**Mastergroup Lot 11 Trust**

**Site Audit Report & Site Audit Statement**

**Richards Road, Riverstone, NSW Lot 11,  
DP816720,**

**20 December 2013**

### Small Building

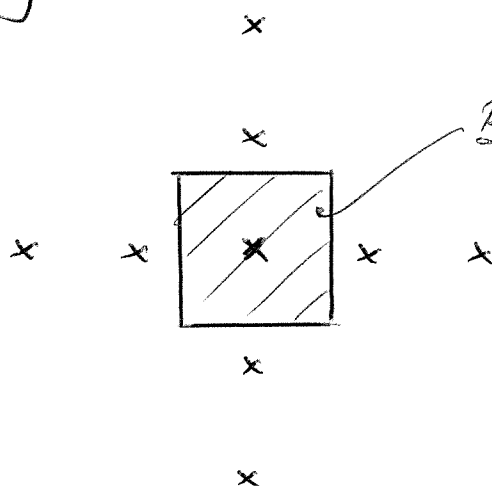
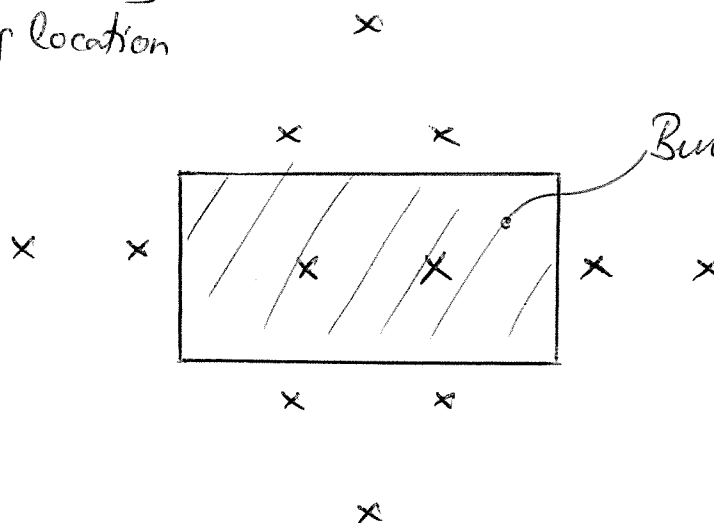
AEC	Feature	Auditor's Comment
1	Settling Ponds	<p><u>Pond Walls</u></p> <p>Based on the Auditor's experience, the walls around these ponds are almost certainly derived from clayey soils sourced from the area covered by the ponds, and should not include waste materials or imported fill. Thus, the Auditor does not require sampling of the pond walls.</p> <p>The Auditor requires visual inspection of the pond walls (inside and outside of the ponds) for evidence of possible inclusion of foreign materials in the pond walls. The Auditor notes that ACM pipes in the pond walls are a separate AEC.</p> <p><u>Pond Base</u></p> <p>The Auditor considers that the proposed sampling density is too sparse for the 3 to 4 hectare coverage of each pond.</p> <p>The Auditor requires a minimum of 16 samples for each pond, with the distribution fanning out from and more concentrated in the low point of the pond.</p> <p>The Auditor requires a Sketch showing proposed sample distribution for AEC 1.</p>

AEC 11 - Largest Footprint only.

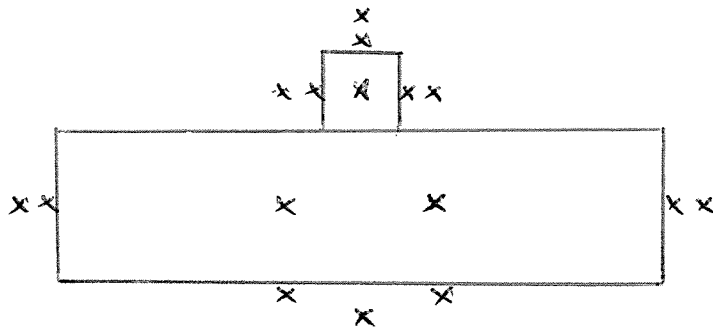
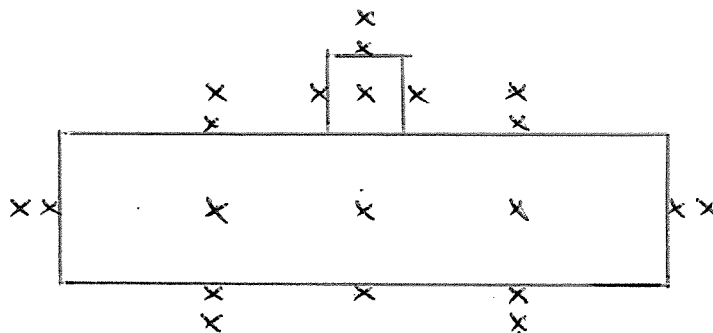
SESL Proposed : 16 locations

Auditor request : 21 locations
